Technical Information (TI) from Fabric to Dealers.

MODEL and YEAR: EC 250 / 300 2018	SUBJECT: FRONT AXLE	DATE RELEASE: 03/05/2018	TI Nº: GGT - 06
---	-------------------------------	------------------------------------	---------------------------

MEASURE OK → **AXLE OK**

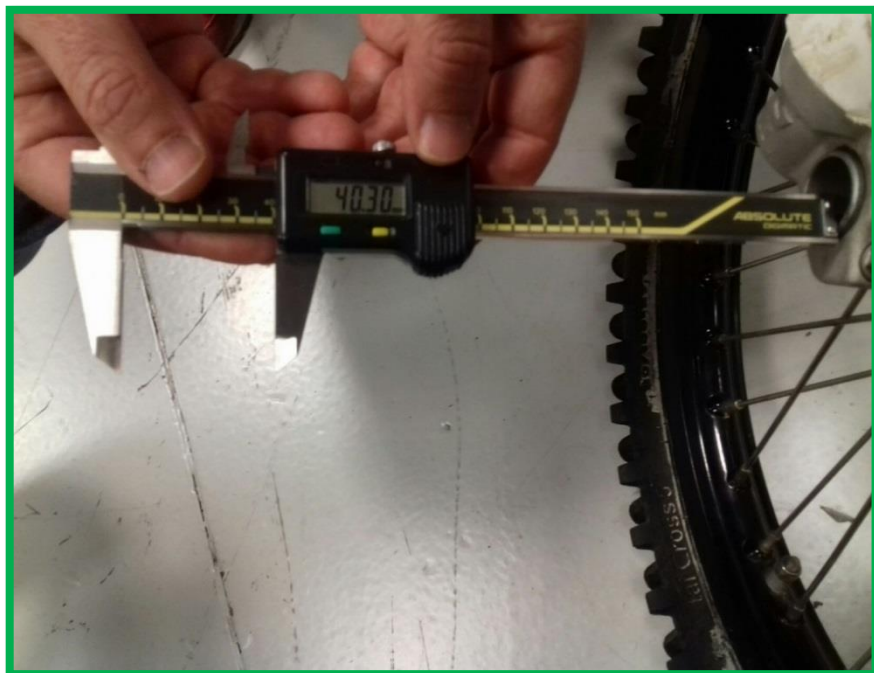
Symptoms:	In very extreme cases, the axle of the front wheel in GASGAS EC 250/300 2018 models could fracture.
Repair procedure:	To know if the axle is correct, the method of verification is the following: The dealer must check the internal depth measurement on the front axle. If it is incorrect, it must be replaced by a correct axle. Some of major markets are receiving some axles for your initial demand. If you need more quantities, you should ask our Spare Parts Department (see below). The verification method is as follows: • <u>Correct</u> measure: 40 ± 0.4 m/m • <u>NOT correct</u> measure: 47 ± 0.4 m/m TECHNICAL ASPECTS:
